# The Second CERCLA Five-Year Review Report for the Hanford Site

Date Published November 2006

U.S. Department of Energy Richland Operations Office

Figure 2. Source Operable Units on the Hanford Site

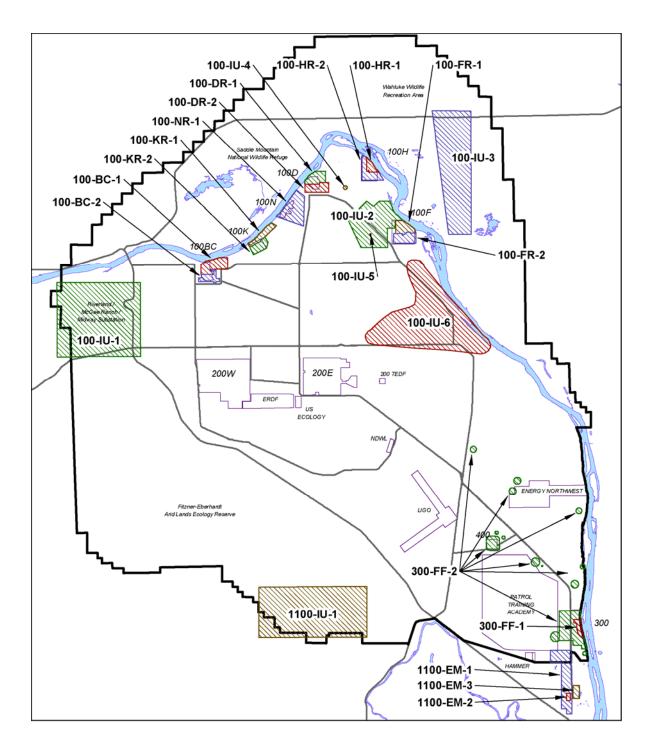
**Comment 34:** Figure 2 shows only one small area in the 200 Area, although there are many scattered sites and 24 soil OU groupings.

**Response to Comment 34**: DOE agrees, the figure does not adequately show the 200 Area operable units. The 200 Area source operable units are shown on Figures 2.1 and 2.2.

Figure 3. Groundwater Operable Units and Groundwater Interest Areas on the Hanford Site

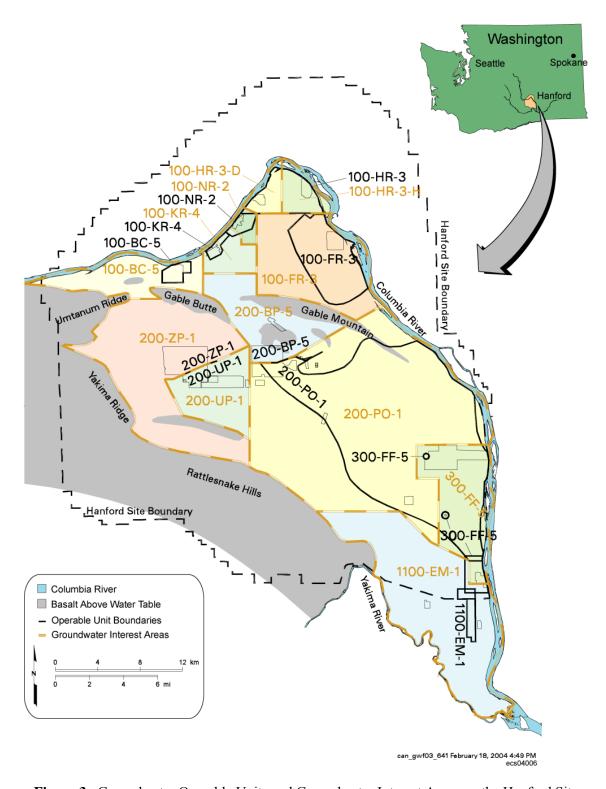
**Comment 36:** Comparing Figures 2 and 3 shows widely divergent Area boundaries – small sources at the surface and huge areas for groundwater. In a 3-D perspective, then, each operable unit would actually be a misshapen cone with the source at the tip, the groundwater at the bottom, and an unknown mass of contaminated soil in between.

Figure 1.4. 100-N Area Operable Units

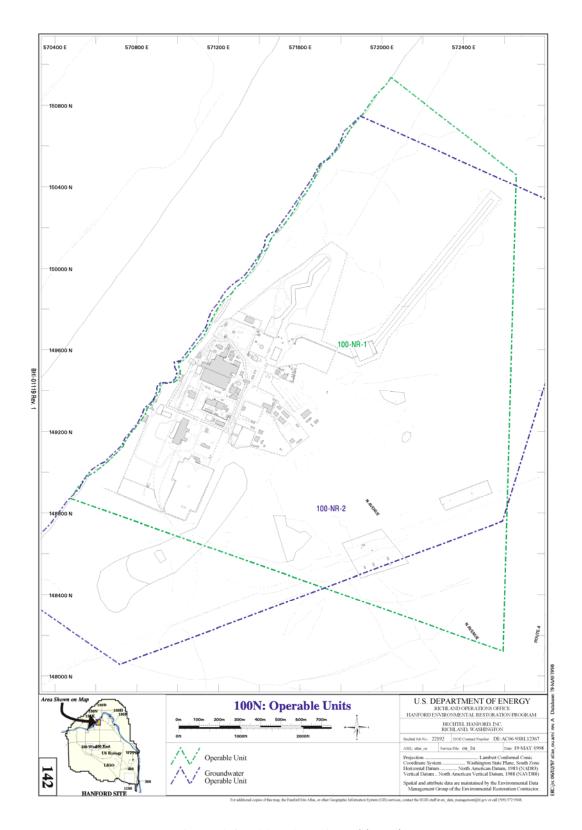
**Comment 32:** The boundaries in Figures 1-4 do not match existing maps for the 100 Area. For example, the 100 Area is variously drawn as the entire River Corridor, a string of pearls (the Reactor Areas), large amorphous areas of groundwater plumes, or larger areas that encompass all of Hanford except the 200 and 300 Areas.

**Response to Comment 32:** Figure 1-4 shows the 100-N Area operable units. It is unclear which maps it is being compared against. See the previous response to Comment 31.

Figure 2.1. 200 West Area Operable Units

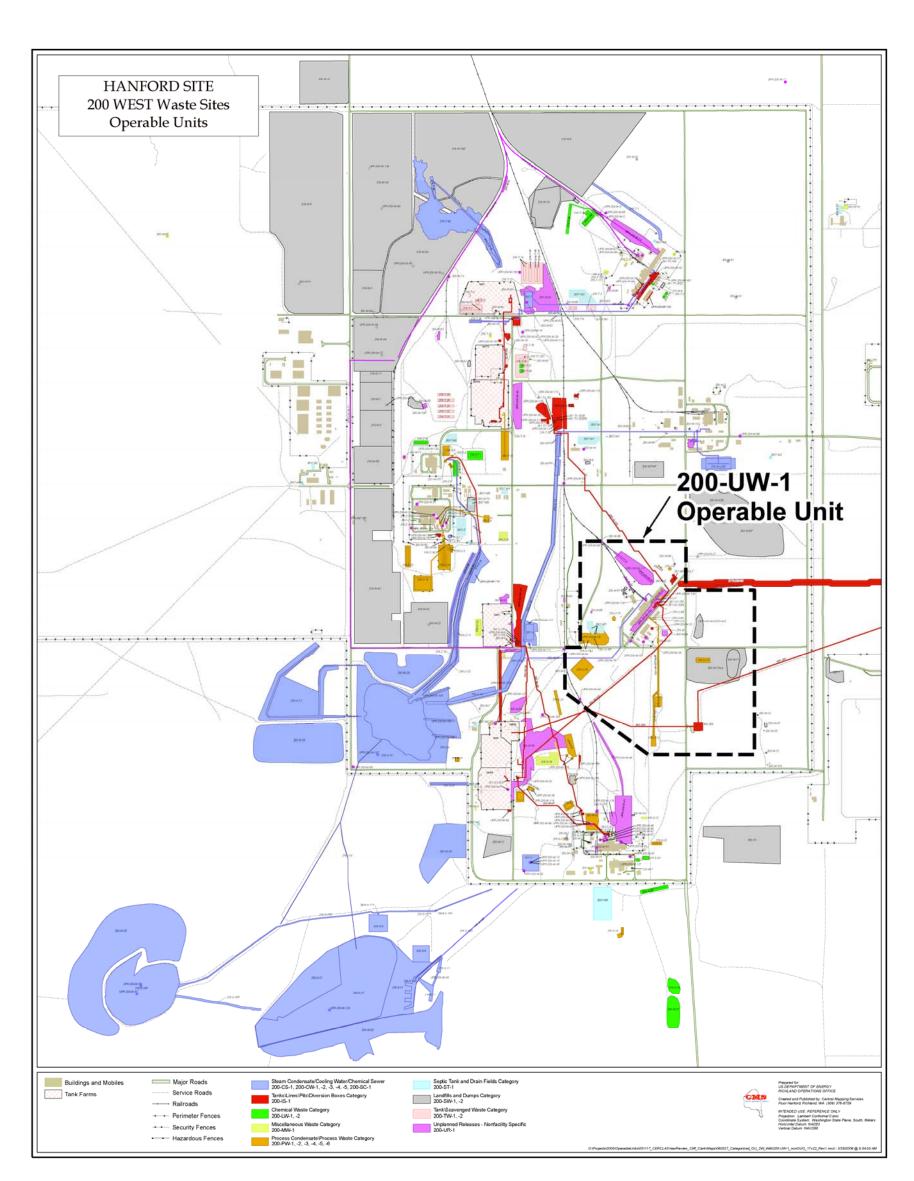
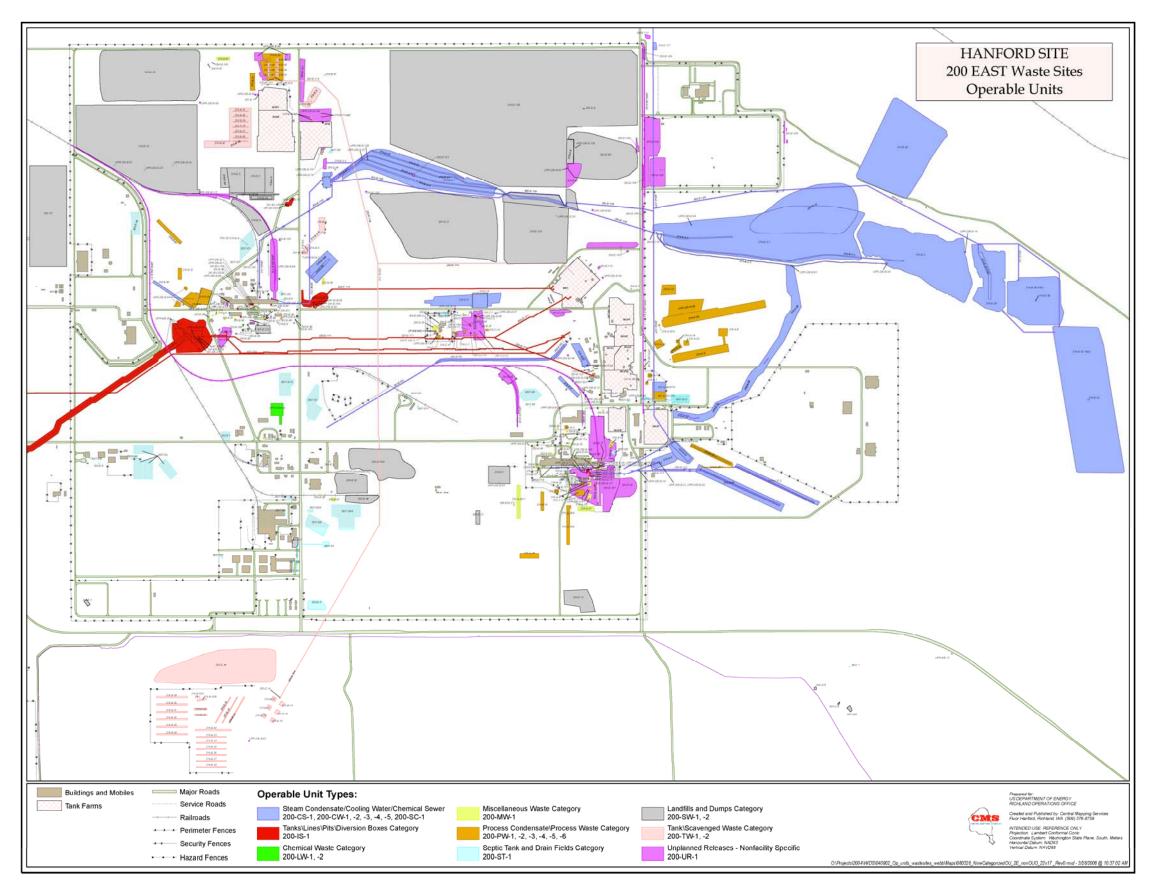
**Comment 74:** Page 2.4 Page 2.5. The operable unit designations in the Figures 2.1 and 2.2 appear to be archaic designations, and should be updated.

Figure 2.12. Tritium Distribution in Groundwater in 200-BP-5 Operable Unit – 2005

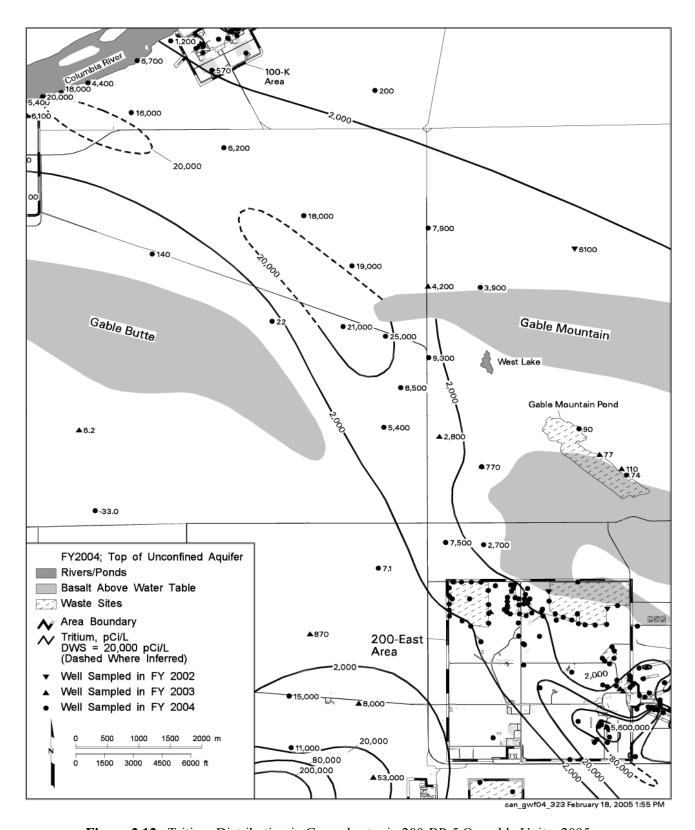
Comment 30: page 2.37, Tritium – Contrary to the text, the distribution of tritium in 200-BP-5 OU differs substantially between 1996 and 2004. Compare Plate 3 (PNNL-11470) and Figure 2.10-4 (PNNL-15070), the distribution of tritium is substantially different in the northeast portion of 200 East Area. Comparing Plate 3 (PNNL-11470) and Figure 2.10-4 (PNNL-15070), the concentrations of tritium have increased in the B-BX-BY area since 1996. The text should be rewritten to accurately describe the changes in tritium distribution in the 200-BP-5 OU since 1996.
